VALUE ENGINEERING REPORT

East Hiram Parkway
Project No.: MSL-0004-00(688) Paulding County
PI No.: 0004688

December 12, 2007

ITEM N^o: G-2
CLIENT: GDOT
Sheet 2 of 4

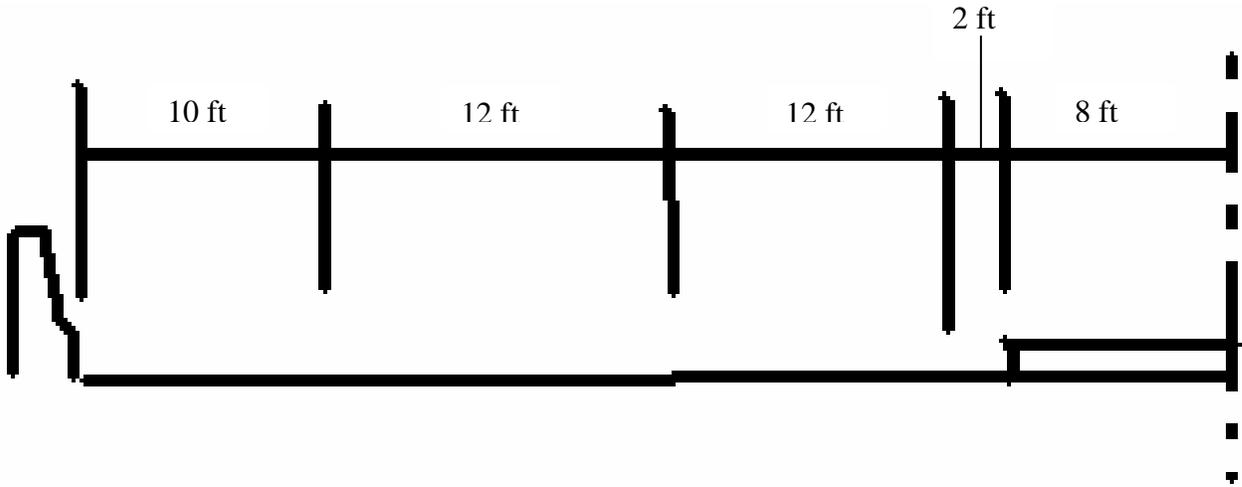
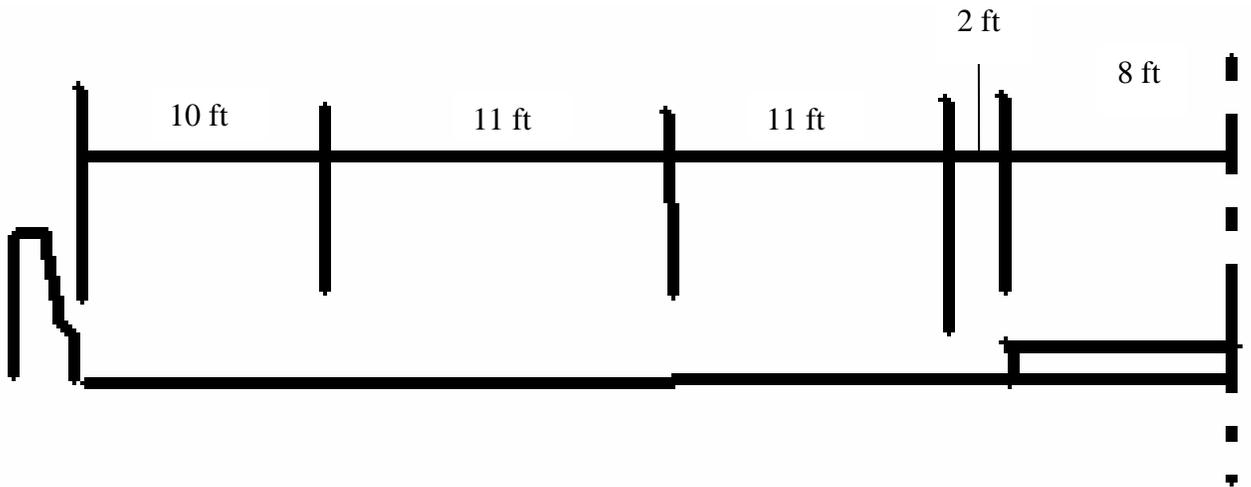
G-2 Use 11 foot lanes on Bridge #2

ITEM N^o: G-2.1
CLIENT: GDOT
Sheet 2 of 4

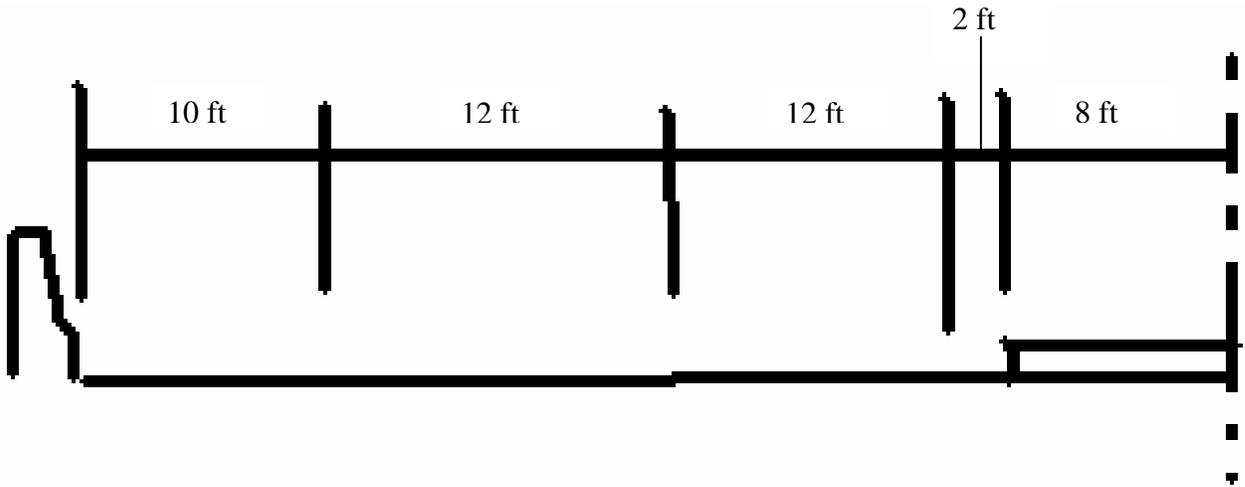
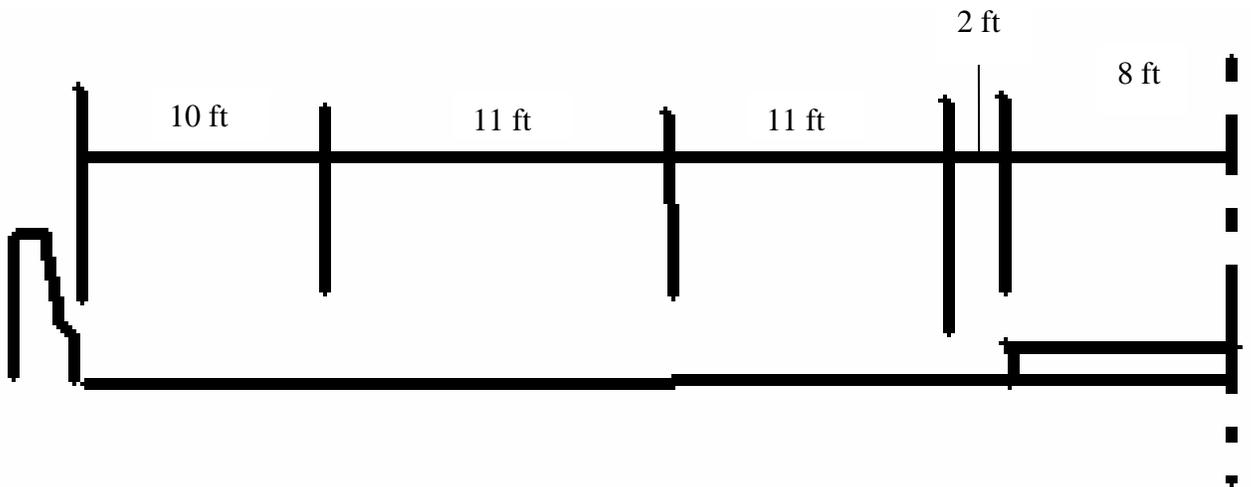
This idea combines the previous two for Bridge #2.
